Appendix B Part 1 of 2 – Road Safety Audits

LAND NORTHWEST OF SOUTHWATER

Proposed Northern Access Roundabout

Road Safety Audit – Stage 1

DRAWING NO.	TITLE
UK0043490.9681-WSP-XX-XX-DR-TP-0103.02	Proposed North Access Roundabout onto Worthing Road

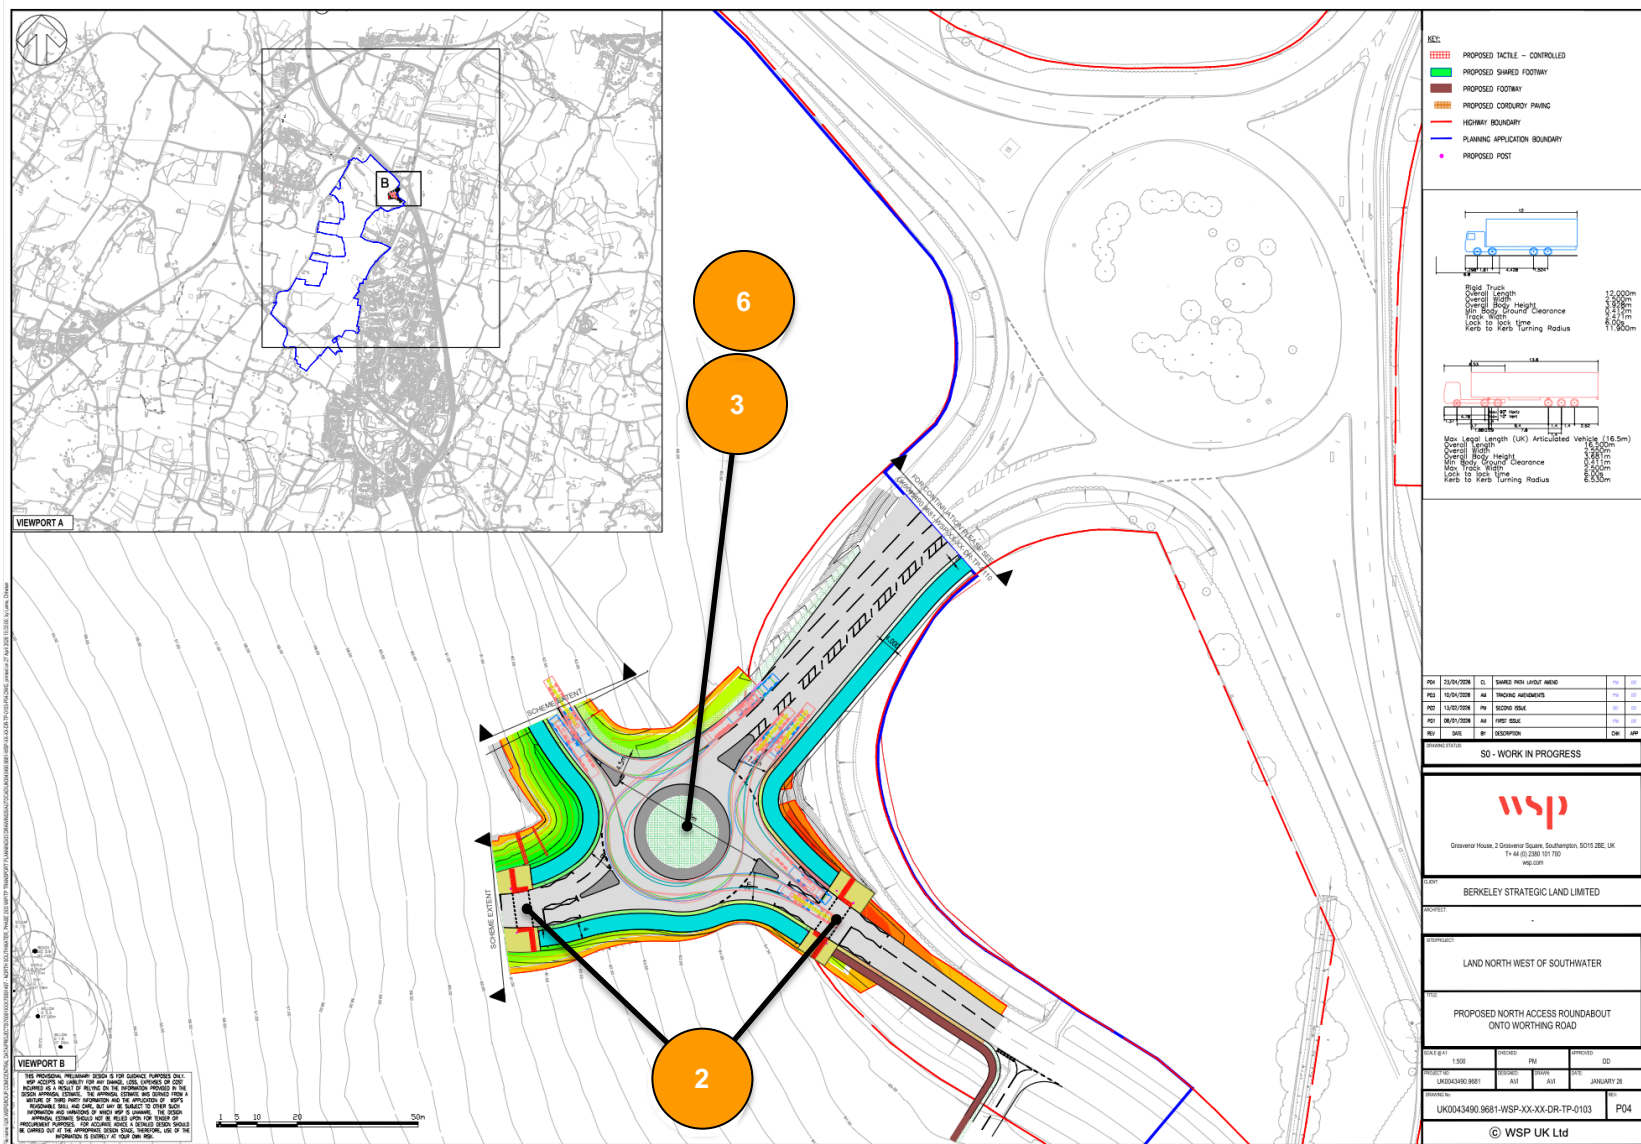
PROBLEM	1
Location	General, throughout the scheme extents
Summary	Insufficient drainage may increase the risk of flooding and single vehicle loss of control type collisions.
Drainage proposals have not been submitted at this stage of audit. The implementation of the proposals will result in a significant change to the existing kerb lines. Lack of surface water drainage may result in surface water ponding with the potential slide risk for vehicles during wet and subsequent cold/freezing weather conditions. This may increase the risk of single vehicle loss of control type collisions. In the vicinity of new crossing facilities this may result in an increased risk of slip/fall by pedestrians.	
RECOMMENDATION	
The Audit Team recommend that at the next stage of design, new drainage appropriate for the proposed highway works is incorporated into the scheme proposals.

PROBLEM	2
Location	Approaches to the proposed controlled crossings
Summary	Insufficient surface skidding resistance approaching the proposed controlled crossing points may increase the risk of vehicle to vehicle rear end shunts, overshoots or vehicle to pedestrian type collisions.

At this stage of audit, no details have been provided regarding skidding resistance of the carriageway surface course. Vehicles approaching the signalised crossings may have to brake hard for a red signal. If the skidding resistance of the carriageway is inadequate there may be an increased risk of vehicle to vehicle rear end shunt, overshoots or vehicle to pedestrian type collisions at the crossing point, particularly when the road surface is wet.

PROBLEM	3
Location	Approaches to the proposed roundabout
Summary	Insufficient surface skidding resistance approaching the proposed roundabout may increase the risk of vehicle to vehicle rear end shunts or junction overshoot type collisions.
At this stage of audit, no information has been provided regarding the skidding resistance of the carriageway surface course. If the skidding resistance of the carriageway is inadequate there may be an increased risk of vehicle to vehicle rear end shunt or junction overshoot type collisions particularly when the carriageway surface is wet.	
RECOMMENDATION	
The Audit Team recommends that at the next stage of audit that the appropriate skidding resistance for a stress site is provided on the approaches to the roundabout.

PROBLEM	4
Location	General surrounding verge area adjacent to proposed pedestrian/cyclist facilities
Summary	Embankment adjacent to proposed footway/shared provision may increase risk of injury to pedestrians/cyclists.

The site visit has established that there is a steep gradient at the bank of the existing verge area where a new roundabout and footway/shared link is to be provided. Proposed cross sections and any associated measures to address the level difference or retainment have not been provided at this stage of audit.

This may result in pedestrians/cyclists falling down the embankment with an increased the risk of injury to pedestrian/cyclists.

PROBLEM	5
Location	General surrounding verge area adjacent to proposed roundabout junction
Summary	Steep embankment is a potential hazard to an errant vehicle
The site visit has established that there is a steep gradient at the bank of the existing verge area where a new roundabout is to be provided. Further there are existing length of VRS. Proposed cross sections and any associated measures to address the level have not been provided at this stage of audit and it is unclear how existing VRS may be affected by the proposals. This may increase the risk of an errant vehicle leaving the carriageway at this location and increase injury to vehicle occupants.	
RECOMMENDATION	
The Audit Team recommend that a RRRAP is carried out to confirm whether protection is necessary at this location and to ensure that any amendments to existing VRS is assessed to ensure that its performance is not affected.

PROBLEM	6
Location	Proposed roundabout junction

Summary	Insufficient carriageway width may increase the risk of side swipe type collisions.
The drawing provided at this stage of audit indicates that a two-lane entry is proposed for three of the junction entries. At this stage of audit, whilst some vehicle swept paths have been provided, these appear to show them encroaching into opposing traffic lanes with an increased risk of vehicle to vehicle side swipe type collisions.	
RECOMMENDATION	
The Audit Team recommend that lane/carriageway widths are sufficient to cater for the intended movements i.e. accommodate two vehicles entering the roundabout side by side. Furthermore, vehicle swept paths should be undertaken to ensure that all turning movements can be safely accommodated.

PROBLEM	7
Location	General, throughout the scheme extents.
Summary	Omission of appropriate corduroy tactile paving may Increase risk of pedestrian to cyclist type collisions.
The scheme drawing indicates that shared and footway only links are proposed. The omission of the required corduroy paving and associated signing may result in pedestrians, particularly blind or visually impaired, not being aware of the presence of cyclists with an increased risk of collisions occurring between these user types.	
RECOMMENDATION	
The Audit Team recommend that the appropriate tactile paving and signing is incorporated into the scheme design.

PROBLEM	8
Location	General, throughout the scheme extents – proposed shared facility

Summary	Risk of vehicle to cyclist type collisions at the points of access and egress to the shared facilities
It is unclear from the drawings provided how cyclists are to access and egress the proposed shared facility This may increase the risk of vehicle to cyclist type collisions.	
RECOMMENDATION	
The Audit Team recommend that at detailed design, a clear cycle strategy is provided showing how cyclists can safely access and egress at the tie in points of the shared facility.

PROBLEM	9
Location	General, throughout the scheme extents
Summary	Existing street furniture, signs and lighting columns may be vulnerable to vehicular strikes due to insufficient lateral clearance.
The scheme proposals indicate that significant kerb realignment is proposed to accommodate a new roundabout junction. At present there are a number of items of existing street furniture, signing and lighting columns, within the adjacent verge areas. From the drawing provided for this audit it is unclear where these will end up being located. Inappropriately sited street furniture may be vulnerable to vehicular strikes due to insufficient lateral clearance.	
RECOMMENDATION	
The Audit Team recommend that all street furniture is sited appropriately.

PROBLEM	10
Location	General, throughout the scheme extents
Summary	Conspicuity of proposed measures during the hours of darkness.

The site visit has established that there is currently street lighting within the scheme extents however, the current levels of lighting may not be sufficient for the proposed improvements.

A lack of street lighting may increase the risk of dark collisions in the vicinity of the proposals.

The Audit Team recommend that the appropriate skidding resistance for a stress site is provided for the approaches to the signalised crossings.

The Audit Team recommend that where verge areas cannot be reprofiled adequately that proposals include the provision to remove the potential for pedestrian/cyclist injury.

The Audit Team recommend that checks are undertaken to ensure the lighting levels throughout the scheme extents are sufficient and that appropriate lighting is included as part of the proposals.

DRAWING NO.	TITLE
UK0043490.9681-WSP-XX-XX-DR-TP-0100-01 P03	Secondary Road/ Chessall Avenue Priority Junction Access Arrangements

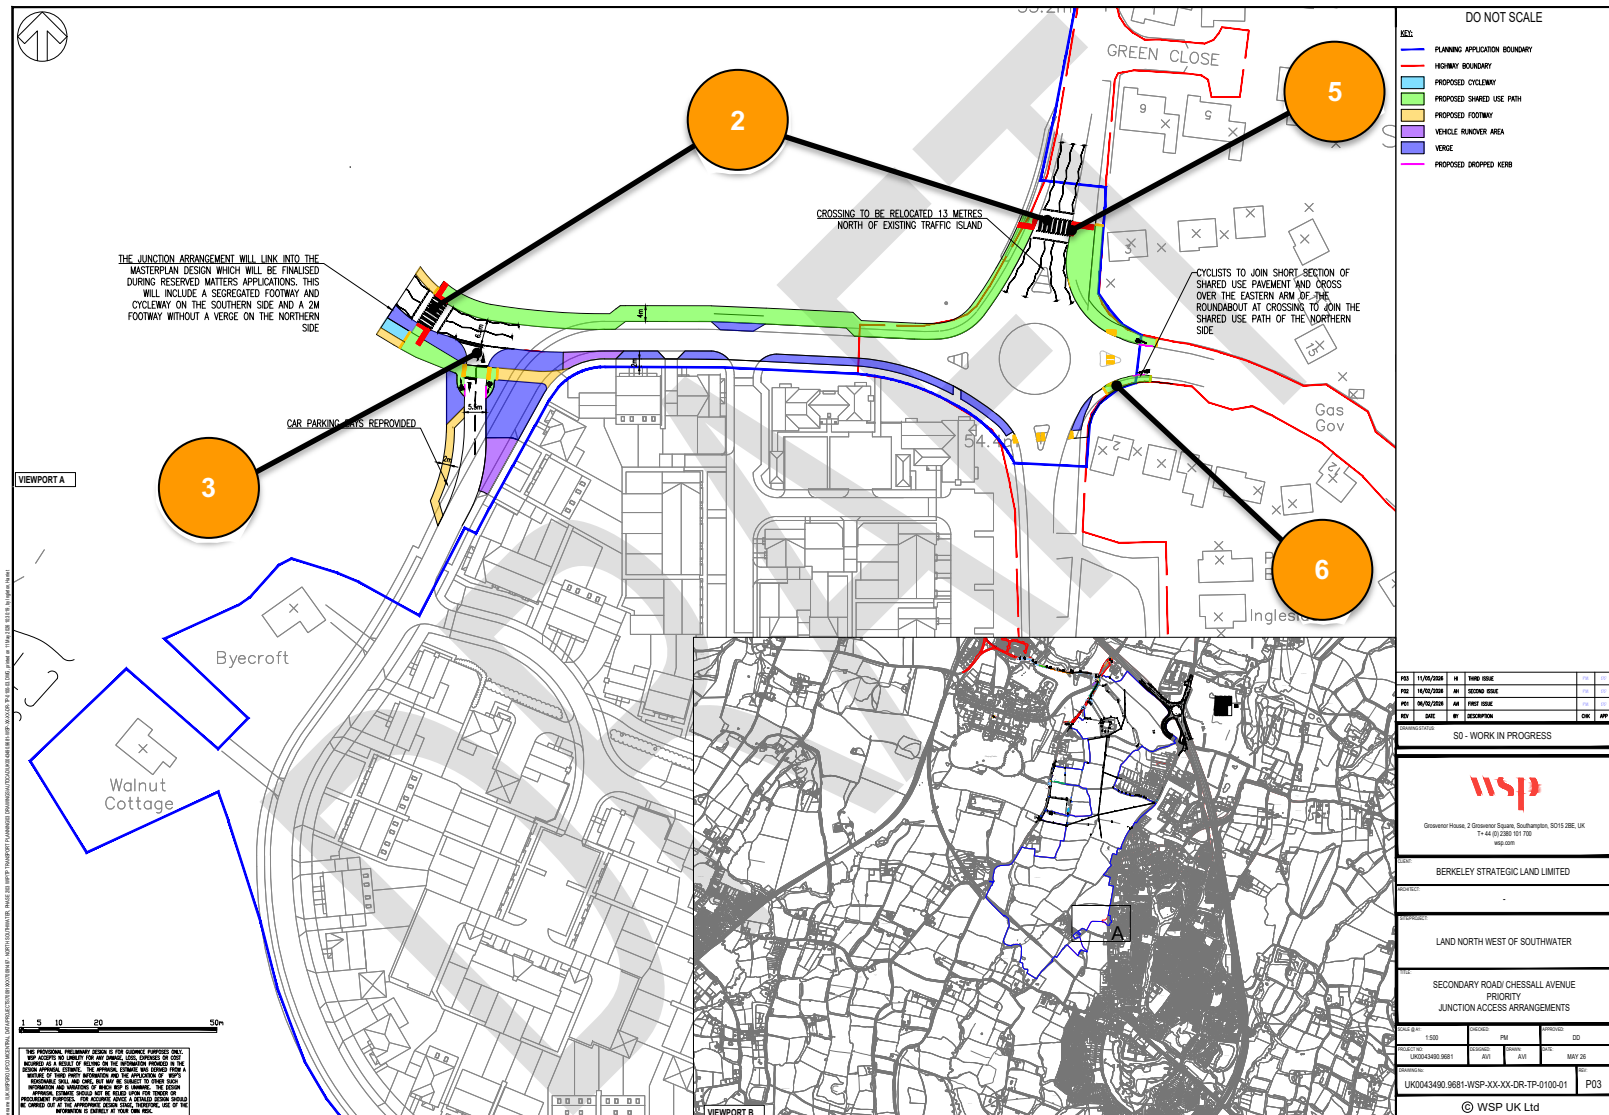
PROBLEM	1
Location	General, throughout the scheme extents
Summary	Insufficient drainage may increase the risk of flooding and single vehicle loss of control type collisions.
Drainage proposals have not been submitted at this stage of audit. The implementation of the proposals will result in a significant change to the existing kerb lines. Lack of surface water drainage may result in surface water ponding with the potential slide risk for vehicles during wet and subsequent cold/freezing weather conditions. This may increase the risk of single vehicle loss of control type collisions. In the vicinity of new crossing facilities this may result in an increased risk of slip/fall by pedestrians.	
RECOMMENDATION	
The Audit Team recommend that at the next stage of design, new drainage appropriate for the proposed highway works is incorporated into the scheme proposals.

PROBLEM	2
Location	Approaches to the proposed controlled crossings
Summary	Insufficient surface skidding resistance approaching the proposed controlled crossing points may increase the risk of vehicle to vehicle rear end shunts, overshoots or vehicle to pedestrian type collisions.

At this stage of audit, no details have been provided regarding skidding resistance of the carriageway surface course. Vehicles approaching the zebra crossings may have to brake hard. If the skidding resistance of the carriageway is inadequate there may be an increased risk of vehicle to vehicle rear end shunt, overshoots or vehicle to pedestrian type collisions at the crossing point, particularly when the road surface is wet.

PROBLEM	3
Location	Proposed new priority junction, Chessall Avenue
Summary	Increased risk of vehicles striking kerbs, pedestrians/cyclists on adjacent footway/shared areas
The drawing provided at this stage of audit indicates that Chessall Avenue is to be realigned and a new priority junction is proposed off its northwestern edge. At this stage of audit, vehicle swept paths have not been provided for the proposed realignment. It is unclear from the information provided whether the relevant design vehicles that may use this junction can safely carry out their turning movements without hitting kerbs. This may increase the risk of kerb strikes and vehicle to pedestrian/cyclist type collisions.	
RECOMMENDATION	
The Audit Team recommend that vehicle swept paths are carried out for all turning movements for design vehicles that are likely to be using the proposed junction. The vehicle swept paths should be safely accommodated within the available carriageway area without hitting the kerbs or overrunning adjacent footway/shared areas.

PROBLEM	4
----------------	---

Location	General, throughout the scheme extents.
Summary	Omission of appropriate corduroy tactile paving may Increase risk of pedestrian to cyclist type collisions.
The scheme drawing indicates that shared and footway only links are proposed. The omission of the required corduroy paving and associated signing may result in pedestrians, particularly blind or visually impaired, not being aware of the presence of cyclists with an increased risk of collisions occurring between these user types.	
RECOMMENDATION	
The Audit Team recommend that the appropriate tactile paving and signing is incorporated into the scheme design.

PROBLEM	5
Location	Proposed zebra crossing, Worthing Road
Summary	Trip hazard for blind/partially sighted or mobility impaired users.
The drawings provided indicate that a new zebra crossing is to be provided across Worthing Road. The site visit has established that there is a gully on the eastern side of the carriageway in the vicinity of the proposed crossing facility. From the information provided it is unclear where these will end up being located. The location of a gully within the width of the tactile paving could present a trip hazard for blind/partially sighted or mobility impaired users.	
RECOMMENDATION	
The Audit Team recommend that gullies are sited appropriately.

PROBLEM	6
Location	Proposed shared facility, Cedar Drive

Summary	Restricted footway provision may result in vehicle to pedestrian/cyclist or pedestrian to cyclist type collisions
As part of the scheme proposals, cyclists are to use a short section of footway which is to be converted to shared use. The site visit has established that the existing footway on the southern side of Cedar Drive is narrow. Converting this section to shared use may result in pedestrians or cyclists using the carriageway to pass one another with an increased risk of vehicle to pedestrian or pedestrian to cyclist type collisions.	
RECOMMENDATION	
The Audit Team recommend that footway widths are appropriate for the proposed use.

PROBLEM	7
Location	General, throughout the scheme extents
Summary	Conspicuity of proposed measures during the hours of darkness.
The site visit has established that there is currently street lighting within the scheme extents however, the current levels of lighting may not be sufficient for the proposed improvements. A lack of street lighting may increase the risk of dark collisions in the vicinity of the proposals.	
RECOMMENDATION	
The Audit Team recommend that checks are undertaken to ensure the lighting levels throughout the scheme extents are sufficient and that appropriate lighting is included as part of the proposals.

The Audit Team recommend that the appropriate skidding resistance for a stress site is provided for the approaches to the zebra crossings.

DRAWING NO.	TITLE
UK0043490.9681-WSP-XX-XX-DR-TP-0101-P03	Worthing Road Site Access Priority Junction Access Arrangements

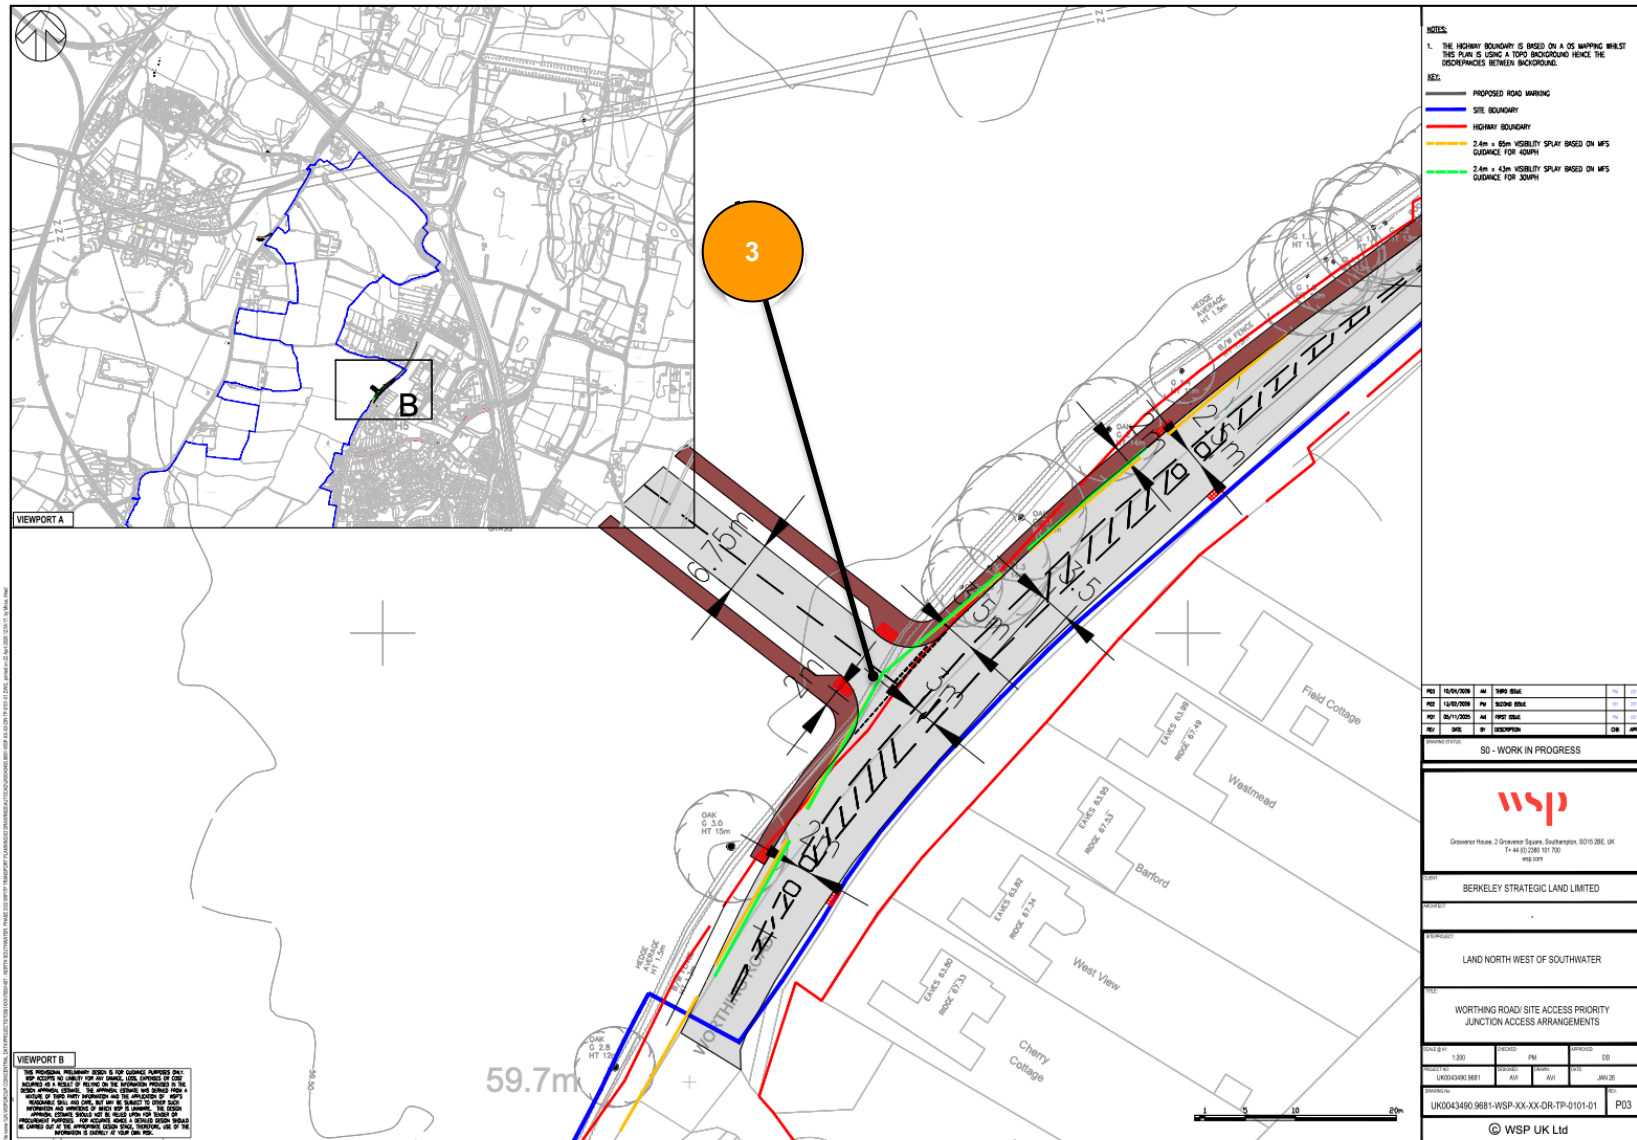
PROBLEM	1
Location	General, throughout the scheme extents
Summary	Insufficient drainage may increase the risk of flooding and single vehicle loss of control type collisions.
Drainage proposals have not been submitted at this stage of audit. The implementation of the proposals will result in a significant change to the existing kerb lines. Lack of surface water drainage may result in surface water ponding with the potential slide risk for vehicles during wet and subsequent cold/freezing weather conditions. This may increase the risk of single vehicle loss of control type collisions. In the vicinity of new crossing facilities this may result in an increased risk of slip/fall by pedestrians.	
RECOMMENDATION	
The Audit Team recommend that at the next stage of design, new drainage appropriate for the proposed highway works is incorporated into the scheme proposals.

PROBLEM	2
Location	General, throughout the scheme extents
Summary	Insufficient tie-in information

The site visit has established that there is an existing double white system along Worthing Road.

It is unclear from the drawings how the proposals will tie into the existing road layout. An unclear road layout may result in an increased risk of vehicle to vehicle and/or vehicle to pedestrian type collisions.

PROBLEM	3
Location	Proposed access junction
Summary	Increased risk of kerb strikes or footway overrun resulting in loss of control or vehicle to pedestrian type collisions.
At this stage of audit, vehicle swept paths have not been provided. Without this information it is unclear whether the relevant design vehicles that may use this junction can safely carry out their turning movements without hitting kerbs/overrunning footway areas. This may increase the risk of single vehicle loss of control or vehicle to pedestrian type collisions.	
RECOMMENDATION	
The Audit Team recommend that vehicle swept paths are carried out to confirm that vehicles can safely negotiate all expected movements. This should include vehicular access/egress for properties on the eastern side of Worthing Road in the vicinity of refuge islands.

PROBLEM	4
----------------	---

Location	General, throughout the scheme extents
Summary	Existing street furniture may be vulnerable to vehicular strikes due to insufficient lateral clearance.
The scheme proposals indicate that widening is proposed on the western side of Worthing Road to accommodate the new junction. At present there are a number of items of existing street furniture within the adjacent verge area. From the drawings provided for this audit it is unclear where these will end up being located. Inappropriately sited street furniture may be vulnerable to vehicular strikes due to insufficient lateral clearance.	
RECOMMENDATION	
The Audit Team recommend that all street furniture is sited appropriately.

PROBLEM	5
Location	General, throughout the scheme extents
Summary	Conspicuity of proposed measures during the hours of darkness.
The site visit has established that there is currently street lighting within the scheme extents however, the current levels of lighting may not be sufficient for the proposed improvements. A lack of street lighting may increase the risk of dark collisions in the vicinity of the proposals.	
RECOMMENDATION	
The Audit Team recommend that checks are undertaken to ensure the lighting levels throughout the scheme extents are sufficient and that appropriate lighting is included as part of the proposals.

The Audit Team recommends that at the next stage of design, tie-in information is provided.
